JEFFERSON COUNTY DRAINAGE DISTRICT NO. 6
Karen K. Johnson, MBA, CTCD/CTCM: Chief Business Officer

IFB Number: IFB 25-029/SC
IFB Title: Howell/Sue Project Materials
IFB Original Due Date: 2:00 PM, January 8, 2026
Addendum No.: 01
Issued (Date): January 5, 2026

Reasons for issuance of Addendum No. 01: **Clarification.**

*PRECAST CURB INLET
UNDER ROADWAY*

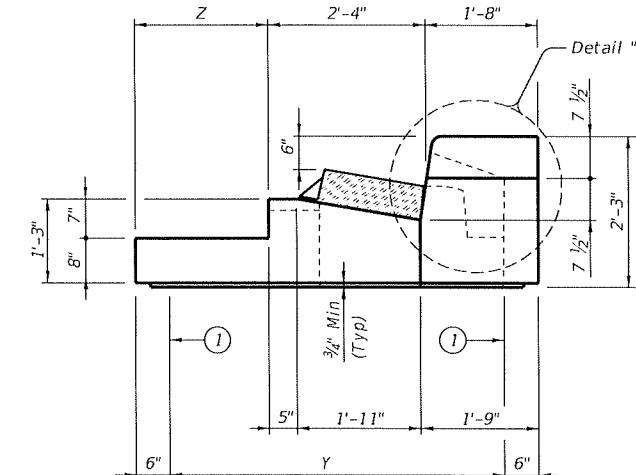
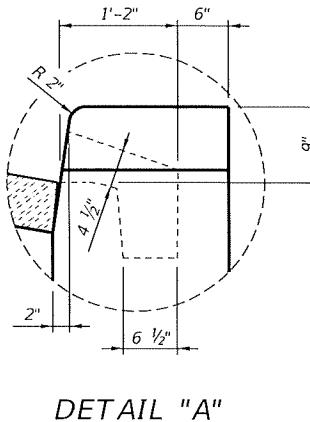
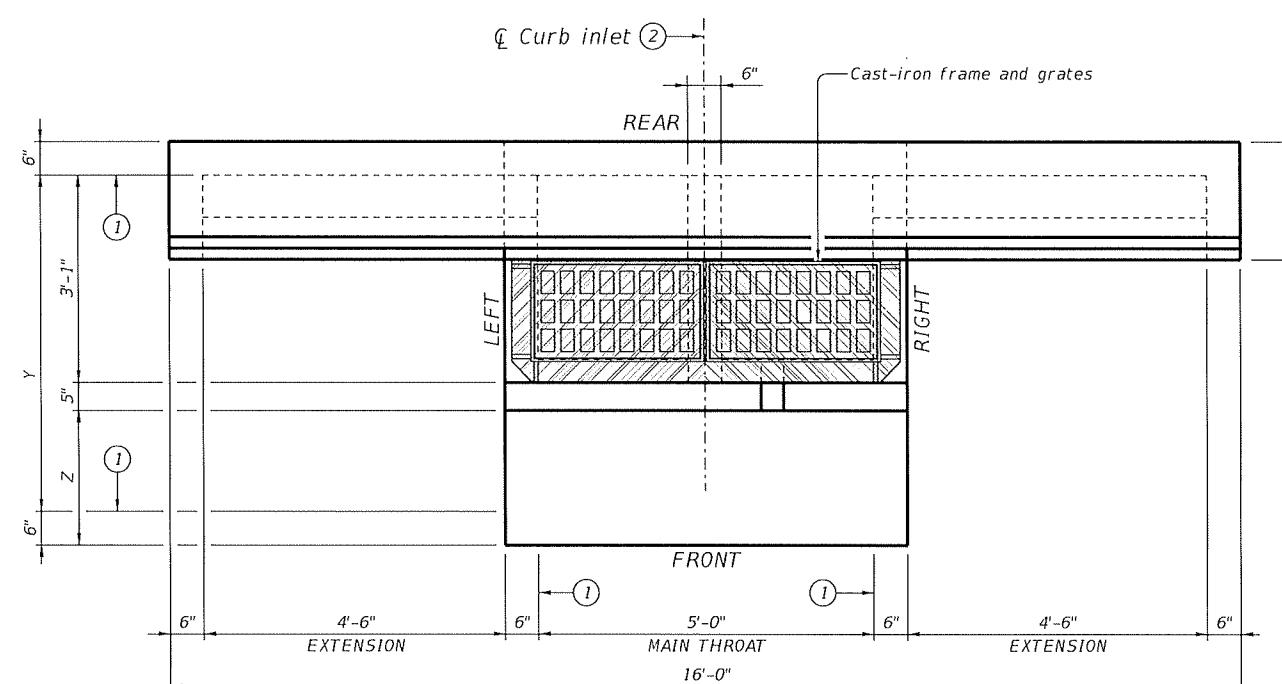
- 1. Are there any drawings for these? Or plans showing how they are going? Yes, they are attached to this addendum.**
 - The "5" in item 2 and the "6" in item 3 represent the "Y" value that is called out in the TxDOT detail on pages 2 and 3 of the attached PDF. They have a standard width as shown in the detail. As for the depth of the manholes and curb inlets, that information is shown for each box/inlet on the plan and profile sheet on page 1. Page 4 is the standard TxDOT detail for manholes. Page 5 is the manhole lid detail.**
